Inspection Photos

Operator: SWN PRODUCTION COMPANY LLC -
10396

Location ID: 313183

Inspection Doc: 696206188

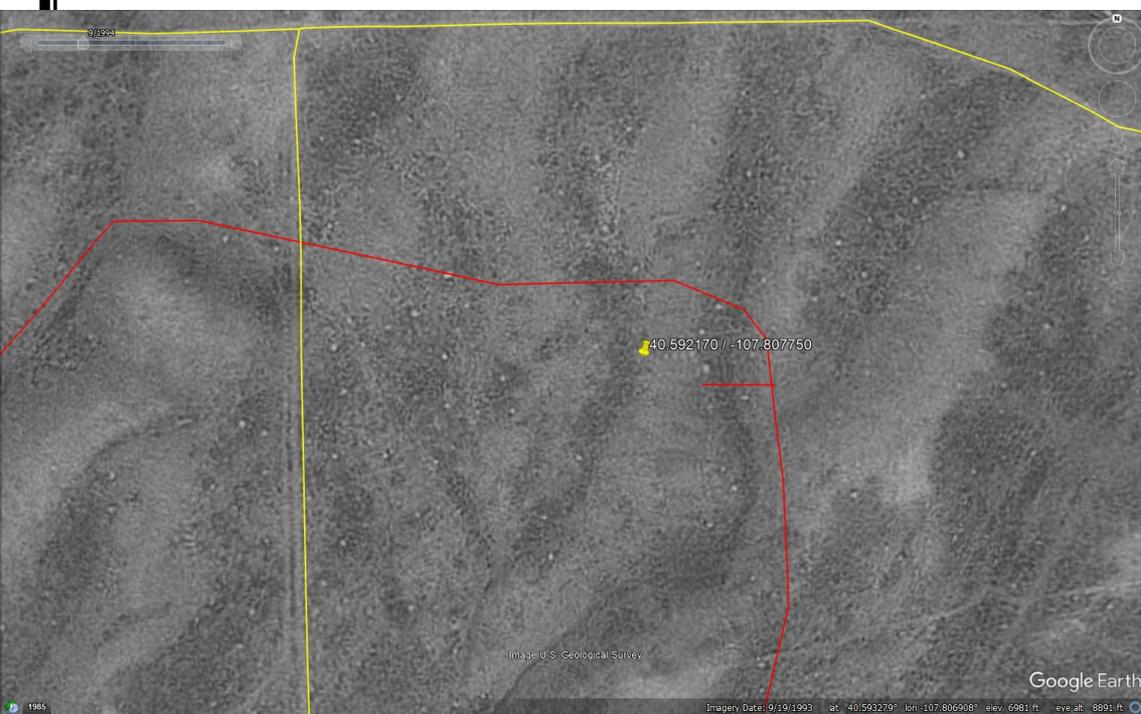
Photo 6: Google earth aerial imagery. Top photo dated 2023; bottom 1994. Yellow lines represent access roads that existed prior to Oil and Gas disturbances. Red lines represent access roads constructed to Oil and Gas Locations subject to 1004 final reclamation requirements. Access road to the Walker 2-11 did not pre-exist the Location.
